Design Review

Parcel V Triangle

Reference: North Point Parcel V Design Review
PB #179
Cambridge, Massachusetts

PARCEL V
DESIGN REVIEW SUBMITTAL

PROPOSED CONDITION - LAYOUT PLAN

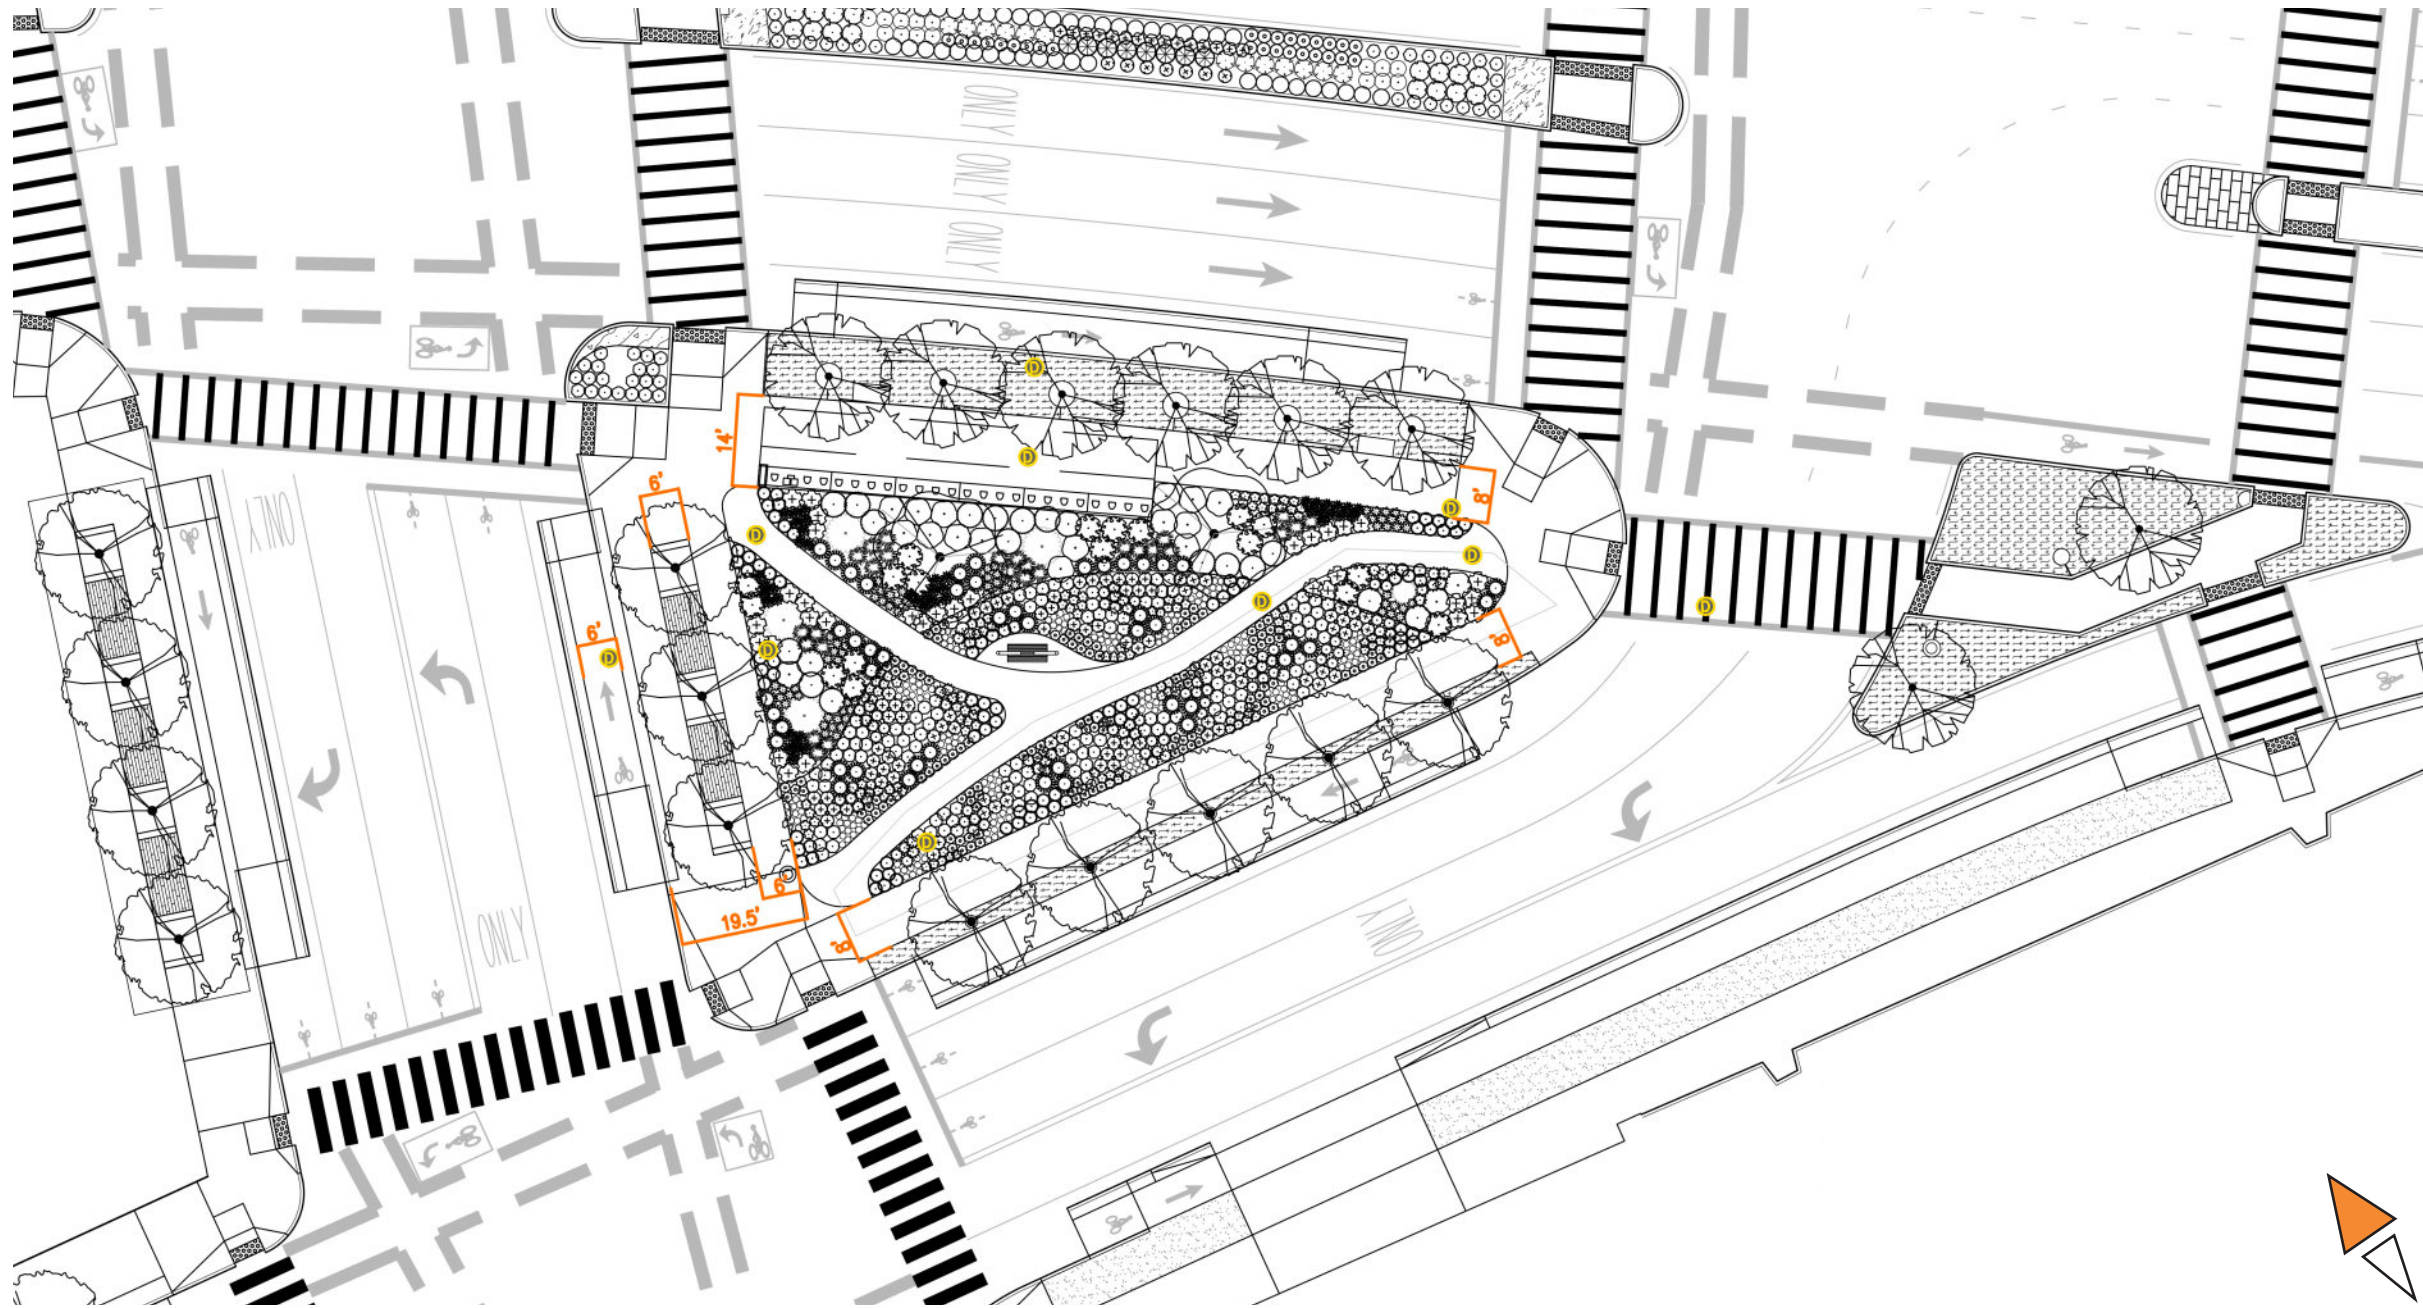
5	[Urban Design] Consider plantings with a lot of color.	DW has confirmed that the proposed plantings have a wide variety of colors.	
6	[DPW] Project needs to incorporate operation and maintenance of infrastructure; show access manhole locations.	DW has revised the drawings to show locations of manhole covers, and has shifted plant locations to facilitate operation and maintenance access.	
7	[DPW] Plant selection needs to consider the depth of the drainage structures. Will root barriers be needed to prevent damage to the drainage structures?	DW has added a root barrier and confirmed that the soil depth above the drainage structure is sufficient for the proposed plants.	
8	[DPW] Provide sidewalk dimensions to ensure accessible routes are achieved.	DW has confirmed that the sidewalk dimensions are adequate to maintain accessible routes.	
9	[TPT] Project should consider public outreach and notification in addition to Planning Board.	DW will provide public notification of the project through its construction mitigation website.

10	[TPT] Cautions against installing trees now that may need to be removed for future development. Consider process and public.	DW has shifted the locations of plantings so that no trees will need to be removed for potential future development.	
11	[TPT] Identify the owner of the parcel and who will maintain improvements. Will street trees be owned by the City?	DW will maintain the street trees in accordance with the already agreed to MOU between the City and DW governing the turnover of streets.	
12	[TPT] Provide dimensions of sidewalks.	DW has provided dimensions of the sidewalks on the drawings.
